## Town of Freedom BOARD OF SELECTMEN

**RE: Input Regarding a Development of Regional Impact (DRI) for a Proposed Gas Station within the Ossipee Aquifer / Groundwater Protection District in Effingham, NH**

## Effingham Site Plan Review, Section I

## Exhibit A

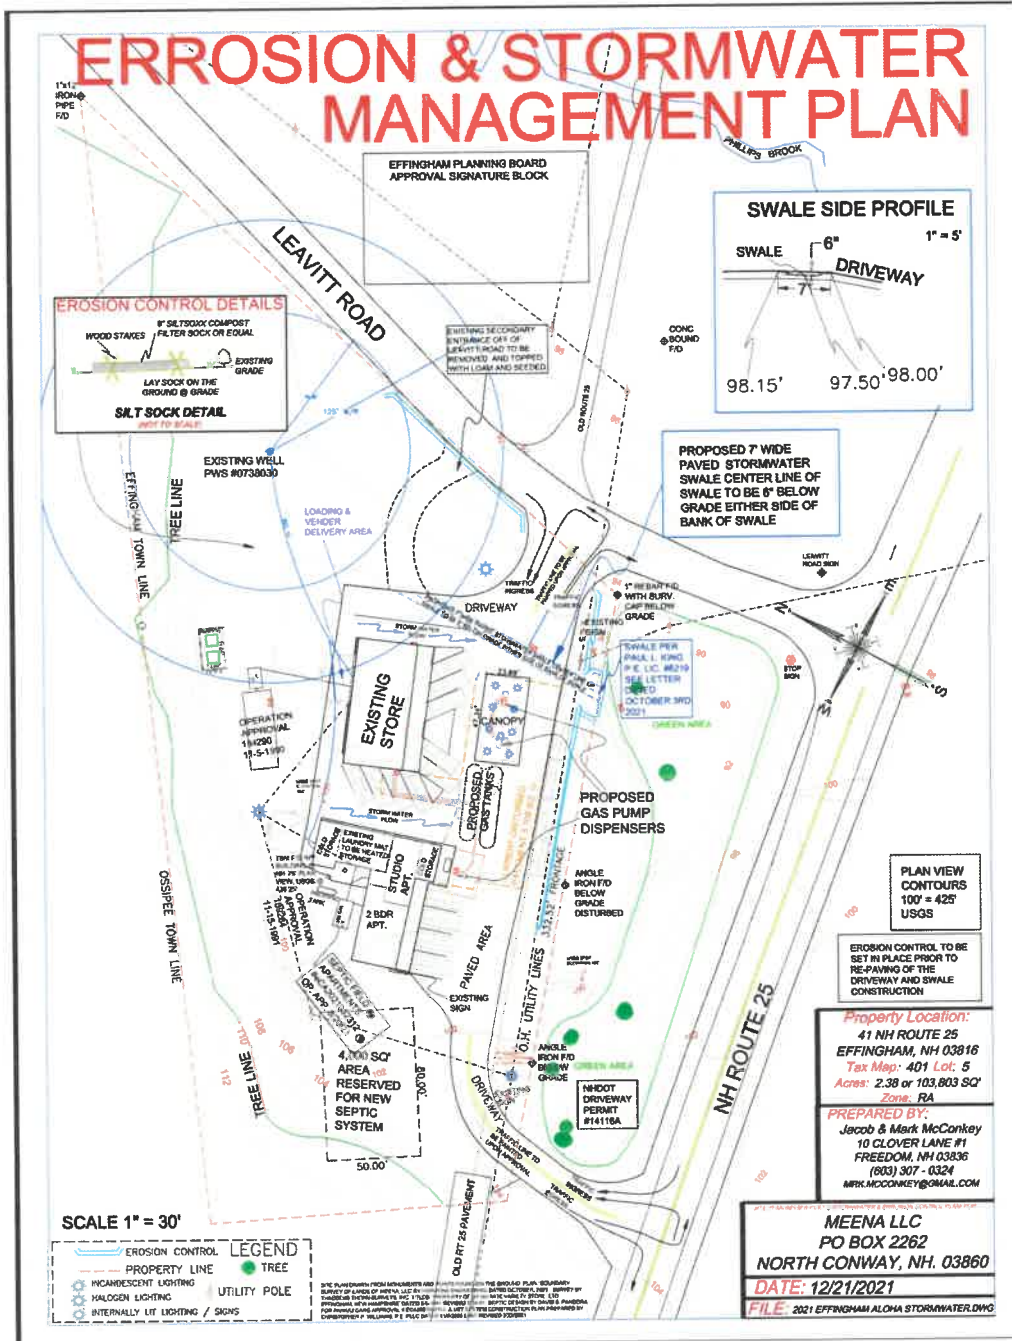
- While there appears to be no significant increase in impervious surfaces that would lead to increase in the peak flow (except perhaps a needed impervious base for the dumpster that is not shown on the plan), there will be significantly increased flow off the site because of a swale added to the site per the plan. This purpose of this swale is to direct significant amounts of additional stormwater runoff into the infiltration basin shown of the plan between the site and Route 25. **See Exhibit A.**

The current Stormwater management Plan provided to the Effingham Planning board from the applicant indicates further measures to direct all stormwater from the site into the infiltration basin. Any accidental gasoline discharge, spills or other such contamination on site will be carried directly into the infiltration basin. Once it has entered the aquifer it will be transported quickly making remediation practically impossible.

## EXHIBIT C

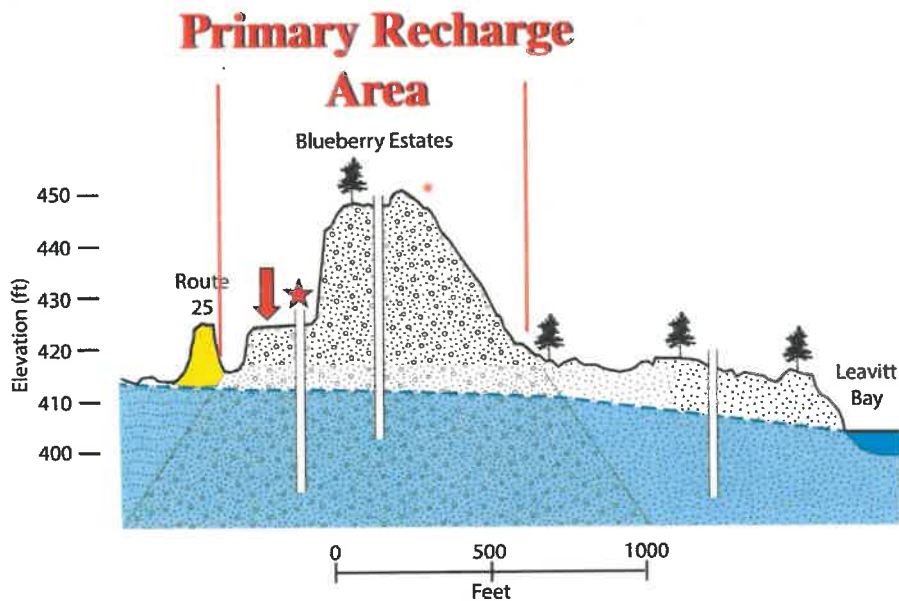
**Exhibit C** illustrates the special circumstances that have raised our concern. The history of this site as a gravel pit means:

- Water flows off the site to the infiltration basin—and the stormwater plan increases that!
- Excavation has removed finer filtration soils creating quicker infiltration
- The site and the off-site infiltration basin are only a few feet above a primary recharge area of the aquifer

LIDAR based contours added to aerial photograph illustrates how the contours of the former gravel pit funnel stormwater from the steep area at the behind the store into the infiltration basin along Route 25. This infiltration basin feeds directly into the aquifer.

Topography of the site shows how close the gas tanks (UST's) and dispensing pumps will be to coarse material that will send runoff or leaks into the aquifer.

LIDAR based elevation graph of cross section. Illustrates the Meena, LLC (red arrow) site sits upon a primary recharge area for the aquifer that has had its finer material removed, revealing coarse material that transports water and potential contaminants directly into the aquifer very quickly. Note that there is a public water supply well on site (star).

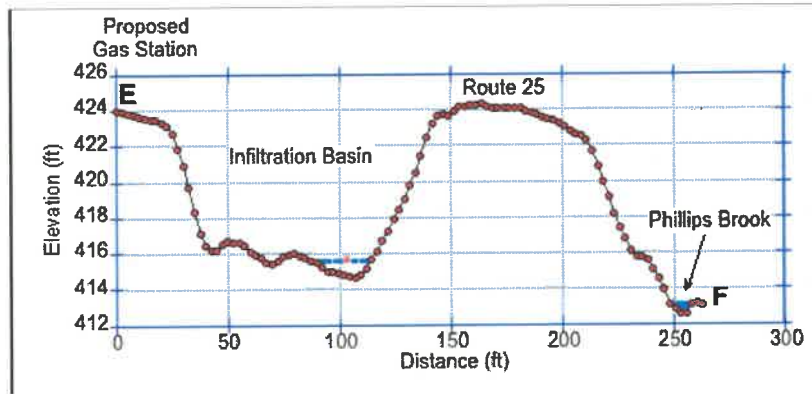
The infiltration basin is just a few feet above Phillips Brook which is an exit point of ground water at this location.

LIDAR based elevation graph of cross section at the infiltration basin illustrates how the basin interacts with Phillips Brook and is an efficient recharge point for the aquifer.
